Re: FCC ID NRR-S4X
Applicant: Bosch Telecom Danmark AS
Correspondence Reference Number: 16227
731 Confirmation Number: EA98749
Date of Original E-Mail: 09/21/2000

Bosch Telecom, EA 98749 -

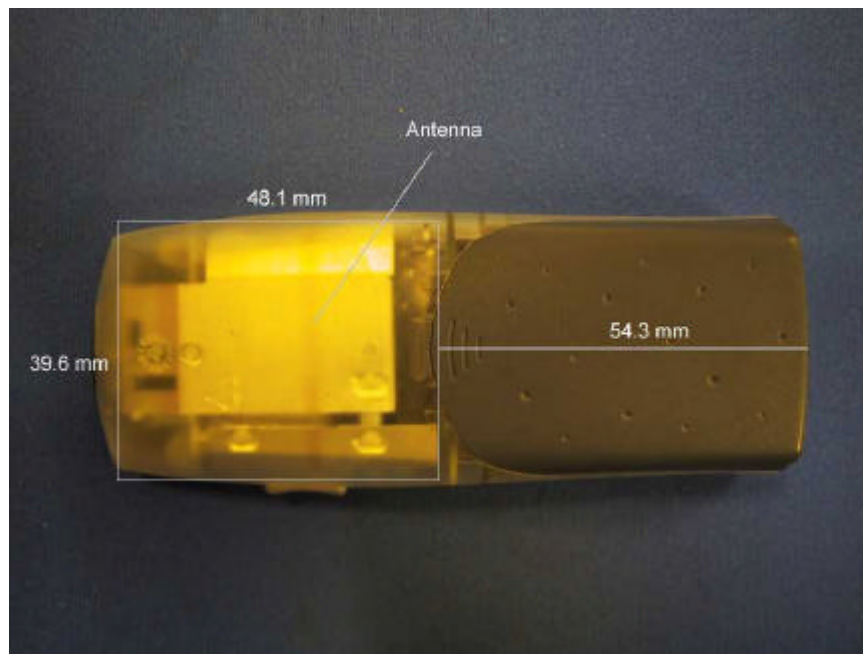
3. The SAR report describes this device has an integrated antenna, please indicate the type and dimensions of the antenna within the device, and identify its precise location within the device.

Response:

This device is equipped with an internal triple band patch antenna. Enclosed below is a picture of the antenna.

The dimensions are:

39.5 x 48.1 x 8 mm (W, L, H)
